Standards Committee

Meeting Agenda

TITLE	Champion
1st time to Committee. Twenty (20) proposed drawings and revisions to WVDOH Standard details Book – Volume 2. The sheets are listed below. A summary of each sheets revisions are included in the meeting packet; and proposed sheets have revised areas highlighted yellow. a) <i>TE1-3A Roadside Sign Supports Steel Beam Type</i> b) <i>TE1-3B Roadside Sign Supports Steel Beam Type</i> c) <i>TE1-3C Roadside Sign Supports Steel Beam Type</i> d) <i>TE2-1A Bridge or Retaining Wall Sign Mounting, Type K 1 & 2 Supports</i> e) <i>TE2-1B Bridge or Retaining Wall Sign Mounting, Type K 1 & 2 Supports</i> f) <i>TE2-2 Bridge or Retaining Wall Sign Mounting, Type L Pipe Post Mount</i> g) <i>TE2-3 Barrier Wall Sign Support Bracket Type D</i> h) <i>TE3-1 Overhead Sign Support – Steel Two Tube Span (TTS)</i> i) <i>TE3-2 Overhead Sign Support – Steel One Tube Span (OTS)</i> j) <i>TE4-3A Overhead Sign Support – Steel Double Arm Cantilever</i> k) <i>TE4-3B Overhead Sign Support – Butterfly Cantilever</i> l) <i>TE4-4A Overhead Sign Support – Single Arm Cantilever (Heavy)</i> m) <i>TE4-4B Overhead Sign Support – Single Arm Cantilever (Light)</i> n) <i>TE4-5

STANDARD SHEET TE5-1A

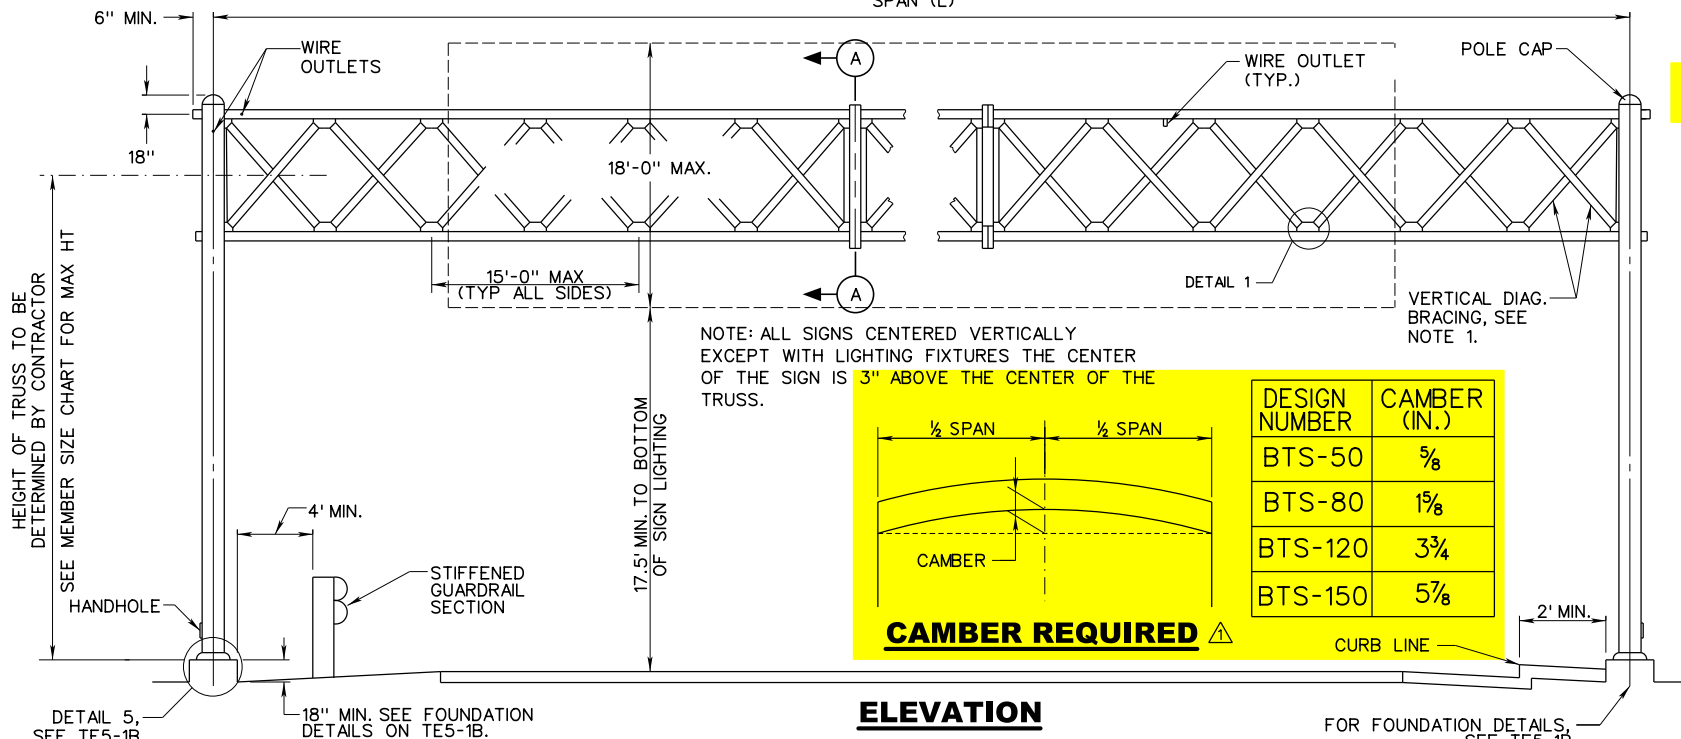
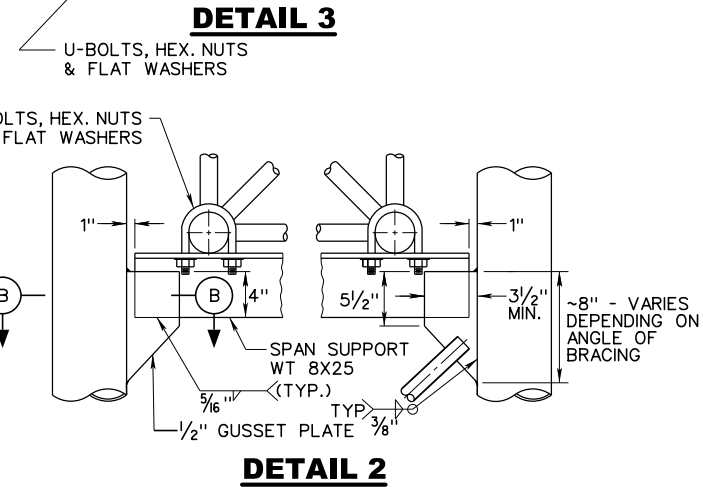
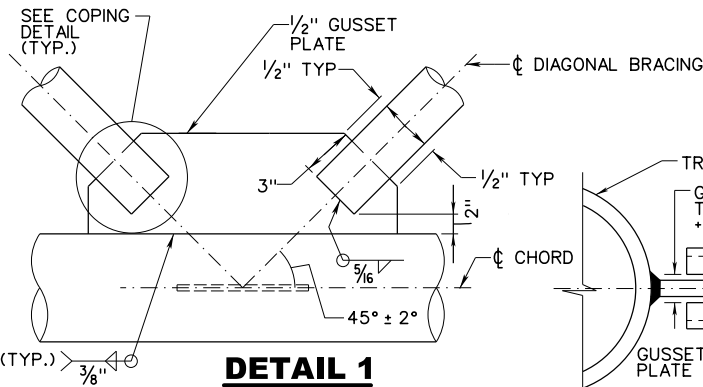
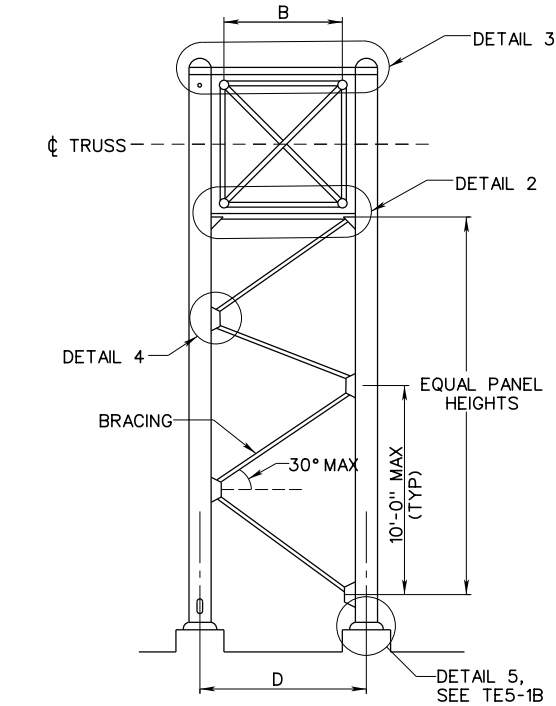
TE4-5	1	11/18/2022	Revised reinforcing based on footing size changes on TE4-4A.
TE5-1A	1	12/19/2022	Added camber information. Revised max span section length.
	2	2/22/2023	Revised chord member sizes. Deleted inappropriate weld.
TE5-1B	1	2/28/2022	Revised foundation reinforcement. Added Detail 8 to clarify reinforcing. Revised/Added bolt projection information. Clarified footing depth/embedment depth on Foundation Detail.
	2	12/19/2022	Updated Chord Splice Table to match changes made to TE5-1A. Deleted 8" post from Base Plate Table.
TE9-1	1	4/2022	Added saddle to all U-bolt connections on Type 2 and Type 3 details. Added Note 8 about including a saddle between the tube and the zee bar.
TEL-41	1	4/2022	Added note 5 to clarify requirements for size and number of hubs.
TES-31	1	3/2020	Revised sign number for pedestrian push buttons.
TEM-2 (2 of 2)	1	4/2022	Specified in notes 7 & 8 that markings that are to be used for turn movements in the middle of the intersection are to be Type V.

STANDARD SHEET TE9-1

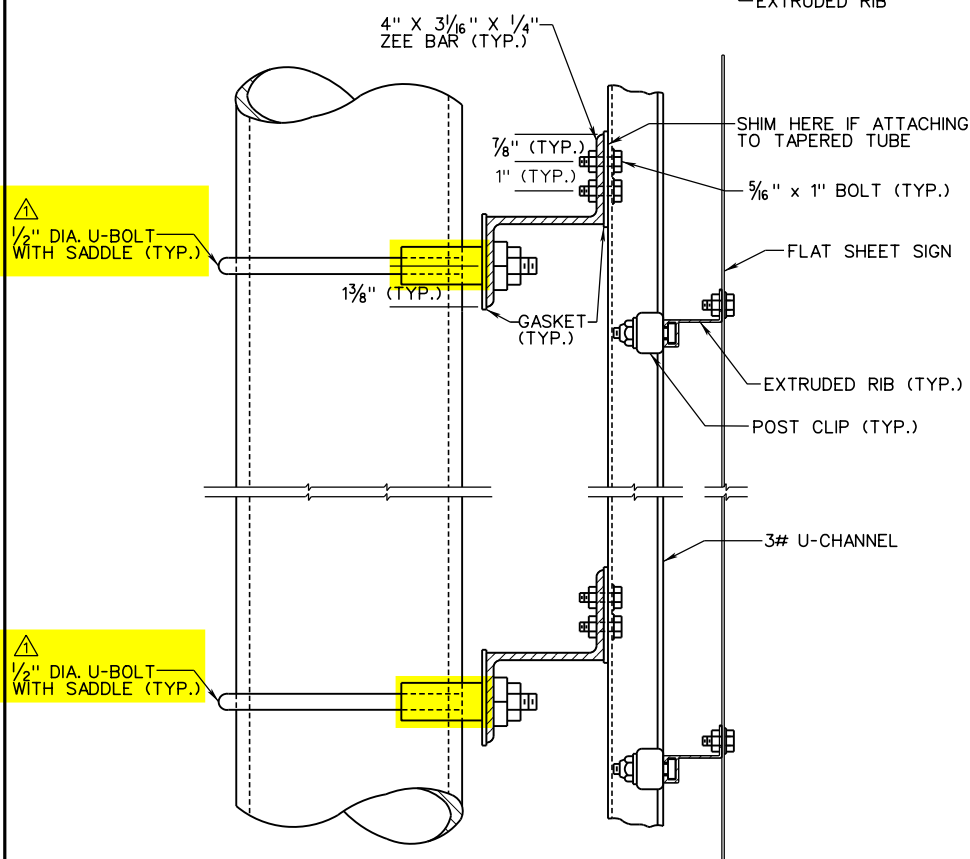
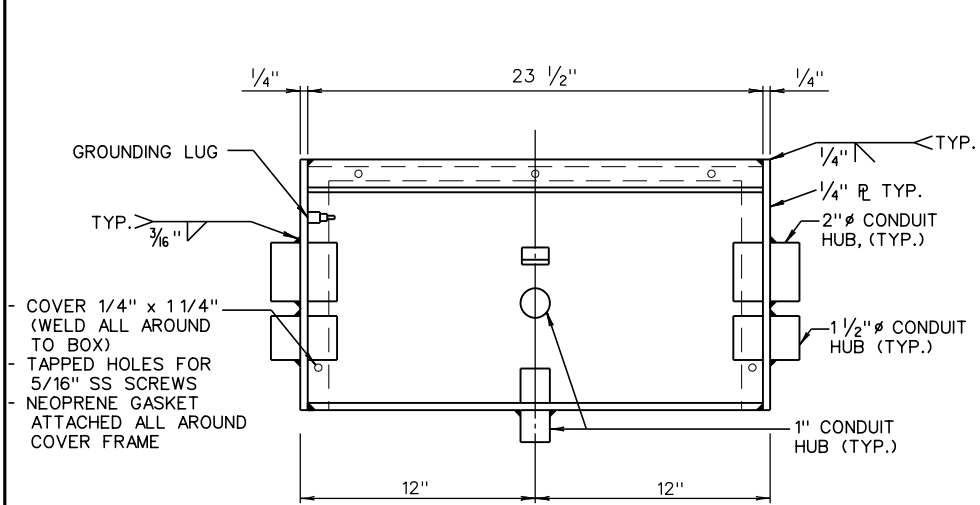
△ 8. ALL U-BOLTS TO INCLUDE SADDLE BETWEEN TUBE AND ZEE BAR.

1 ADDED SADDLE TO U-BOLTS
